**TO: PROSPECTIVE BIDDERS** **DECEMBER 10, 2021**

**RE: IFB-6711 – NEW CONSTRUCTION OF COMMUNITY SCHOOL 35**  
**ADDENDUM NO. 4 - CITY RESPONSE TO REQUESTS FOR INFORMATION AND CLARIFICATIONS**

COMM.WING BASEMENT POWER AND FA PLAN	
Job No.	2019-1026
Date	8/31/20
Scale	AS NOTED
Drawn / Checked	BGA/BGA
Sheet Number	E310

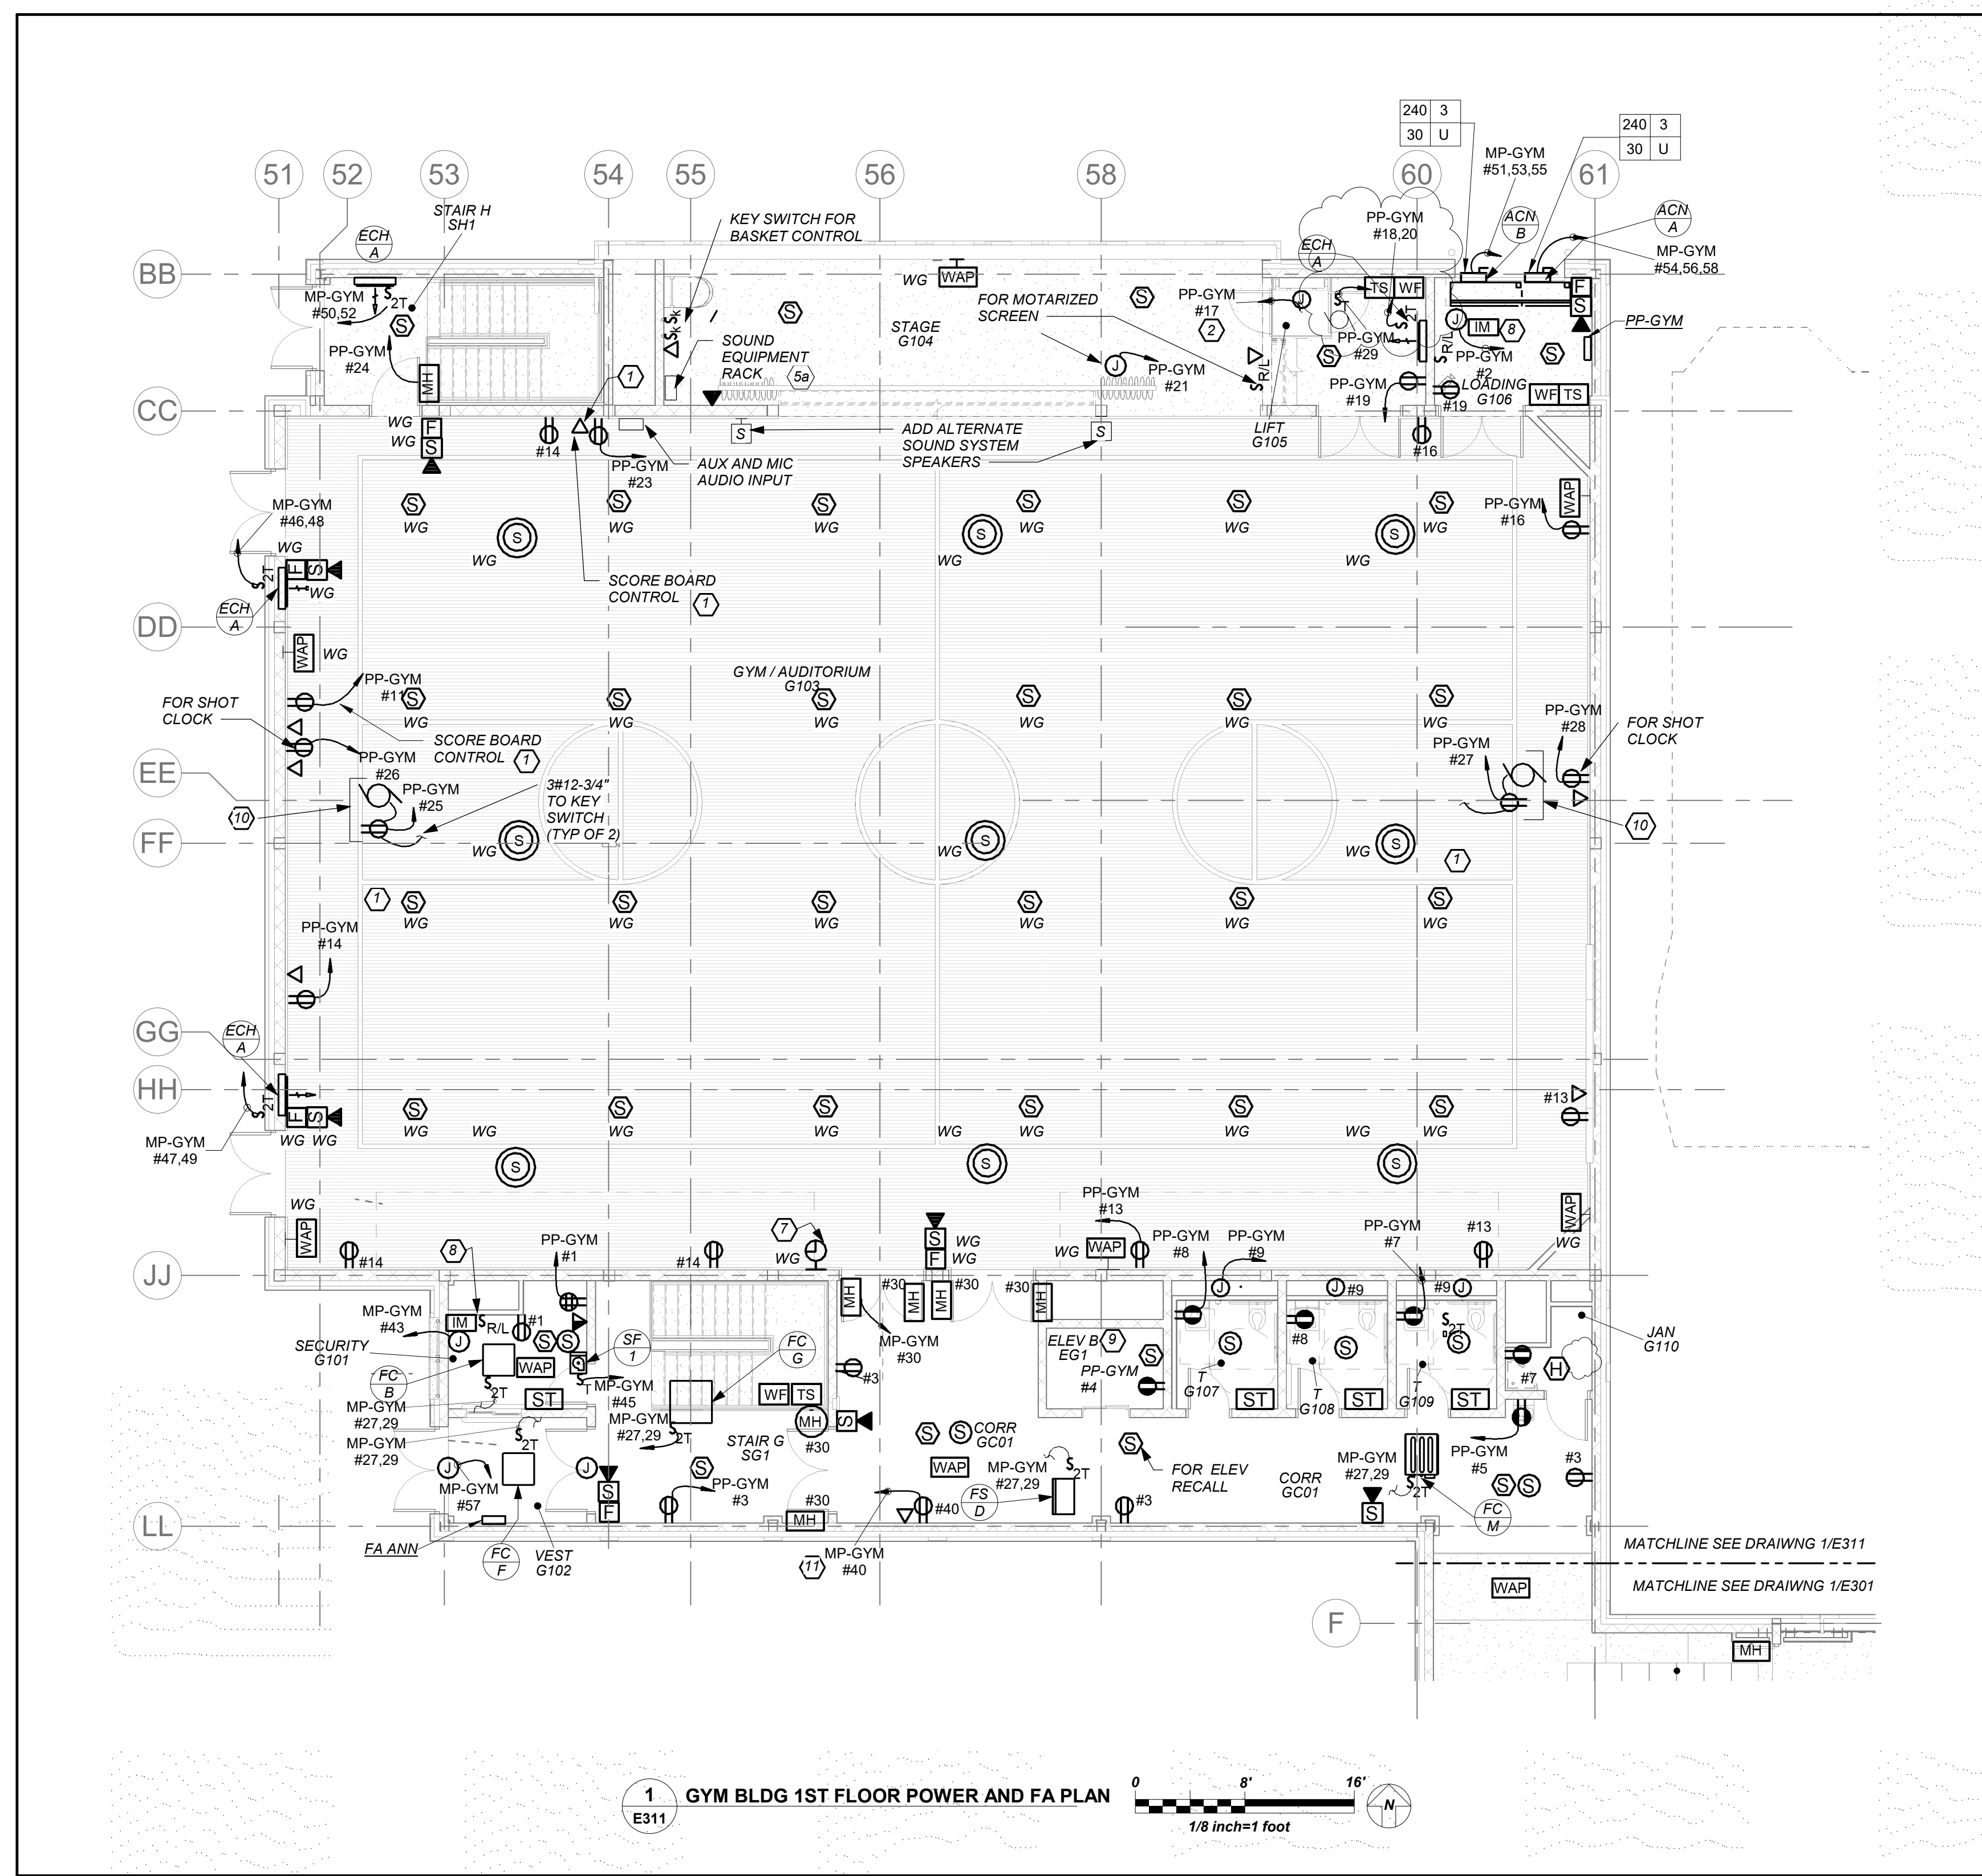
**20. DRAWING E310 – COMM WING BASEMENT POWER AND FA PLAN**

1. Relocate water flow and tamper switch in Stair G SGB.
2. Remove fire smoke damper intended for add alternate work.
3. Provide circuit number 7 for junction boxes in Gym Data Room.
4. Sump Pump Control panel location shown the drawing.

**FEEDER SCHEDULE:**

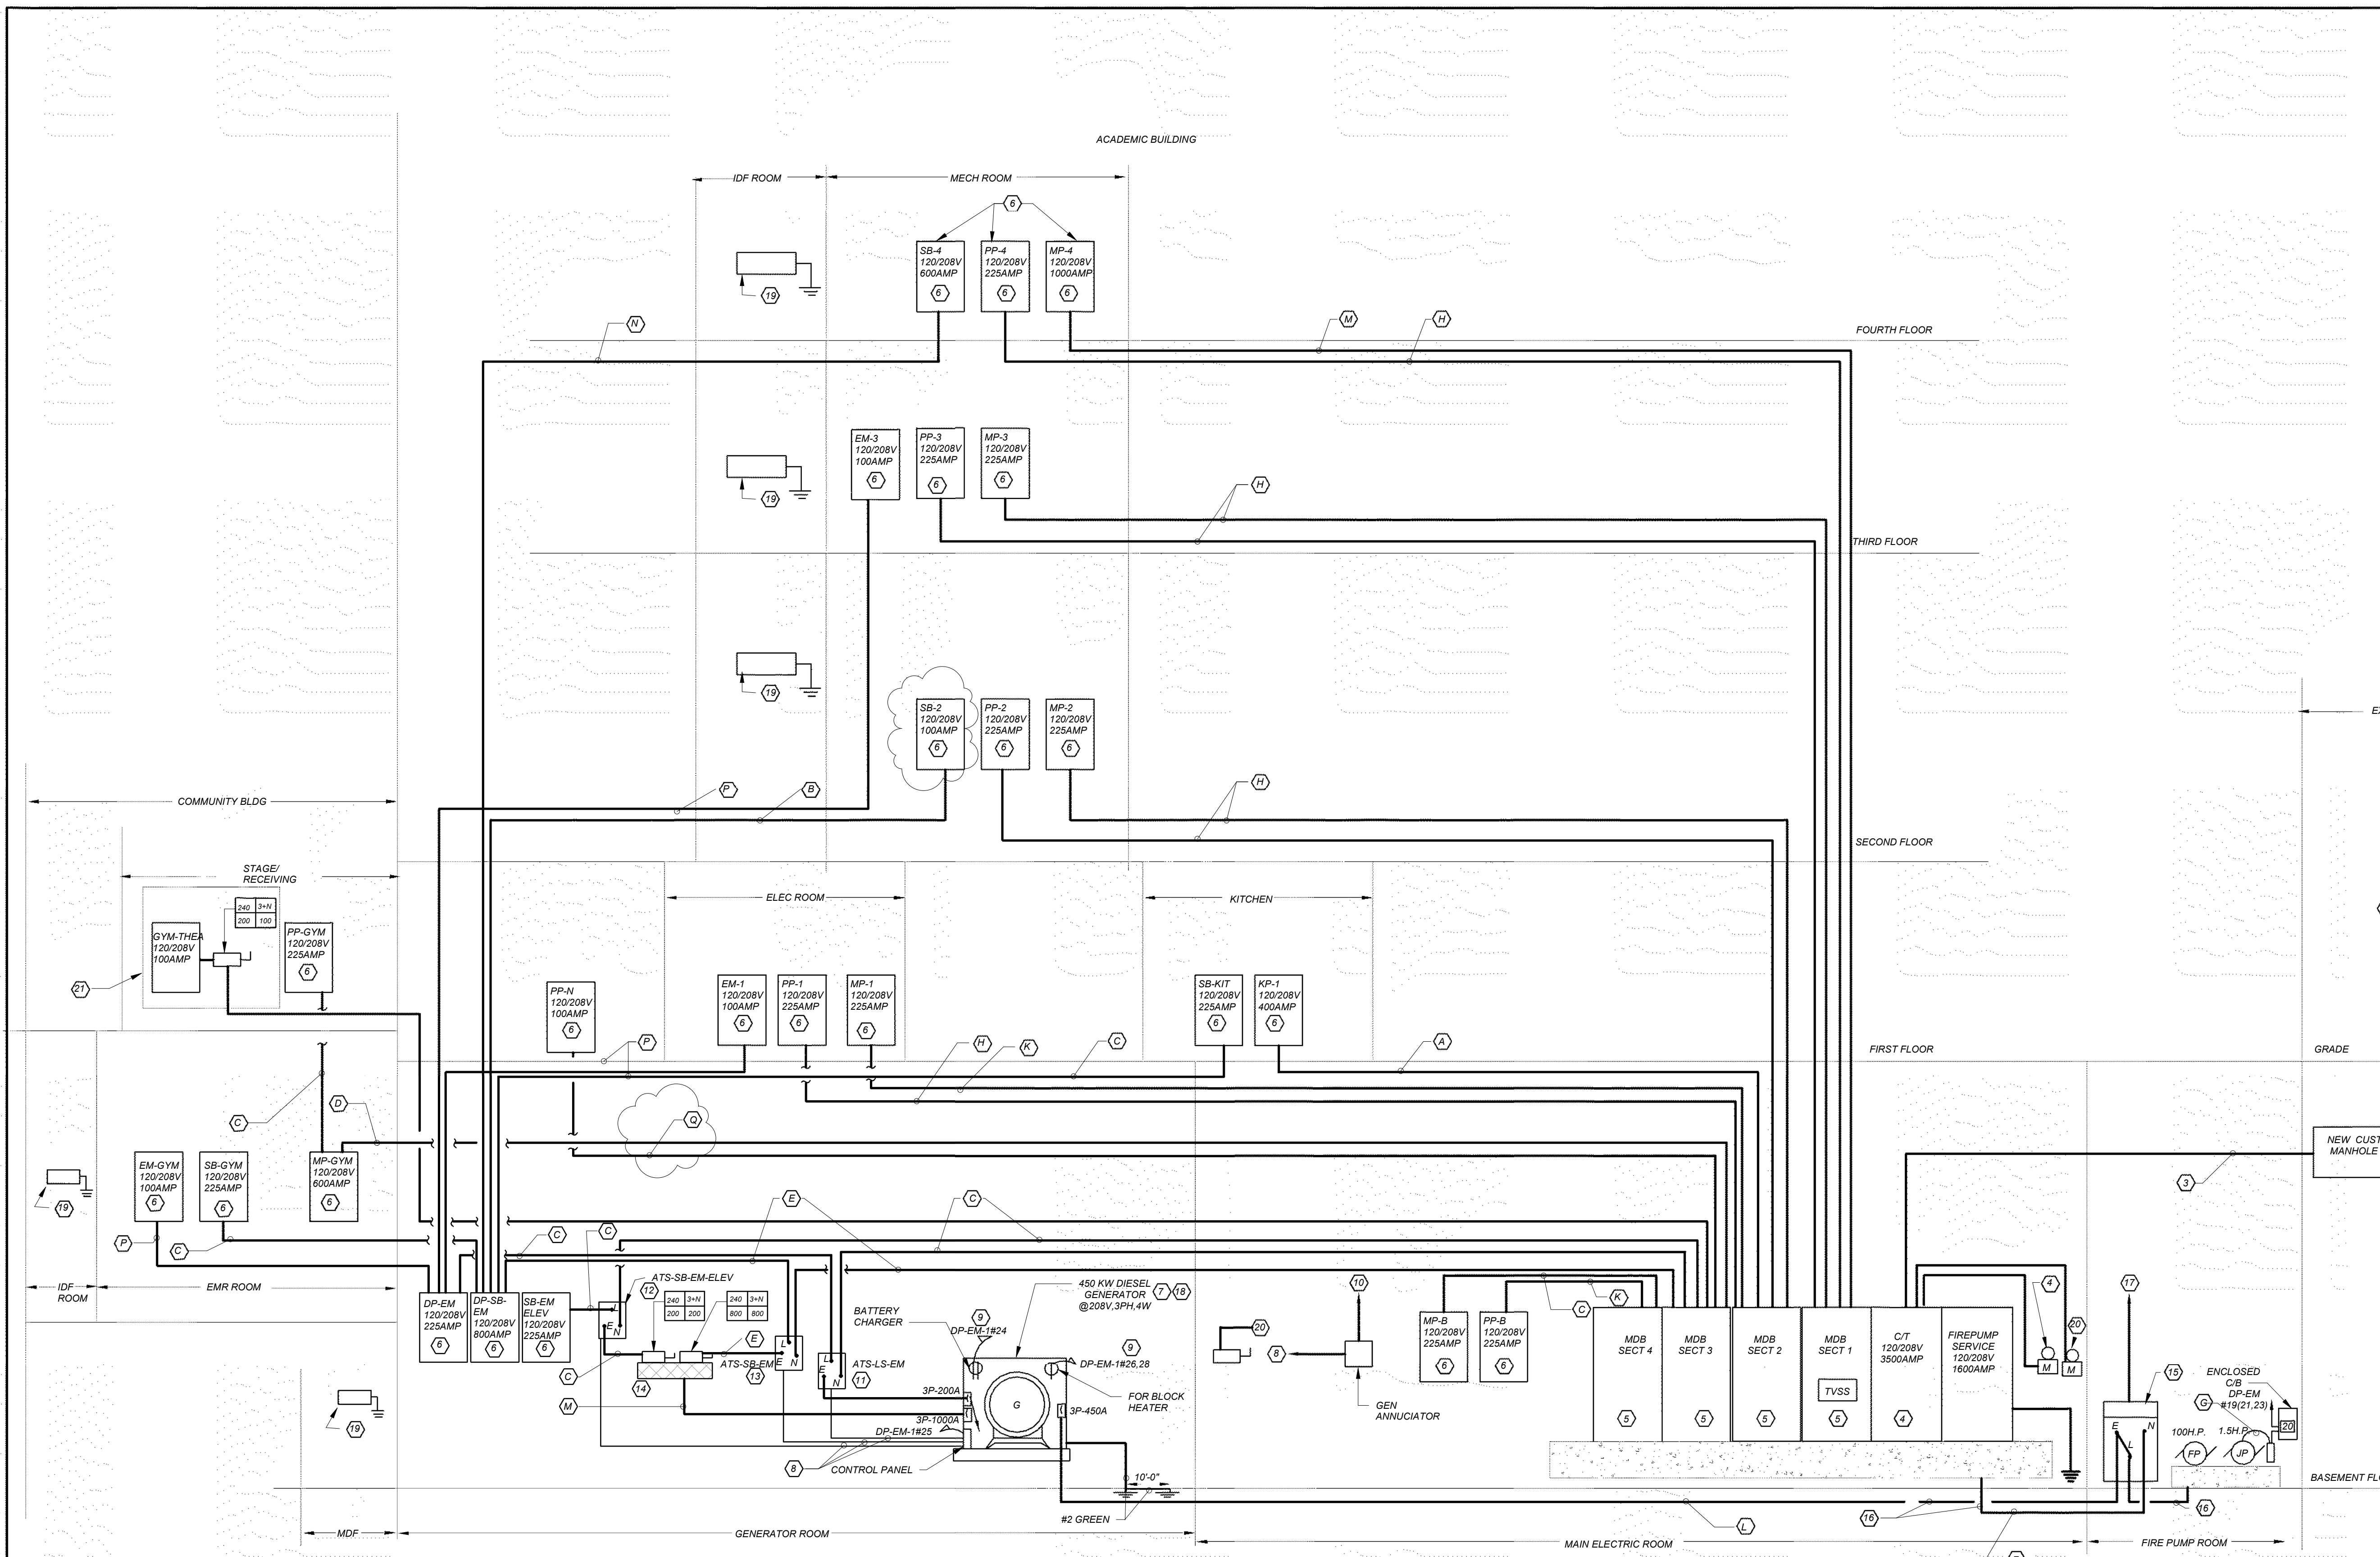
**22. DRAWING E501 – ELECTRICAL RISERS**

1. Revise SB-2 panel to 100A and provide feeder size for circuit Q.
2. Revise MDB circuit 17 to 400 frame size and provide spare for circuits 20-24.
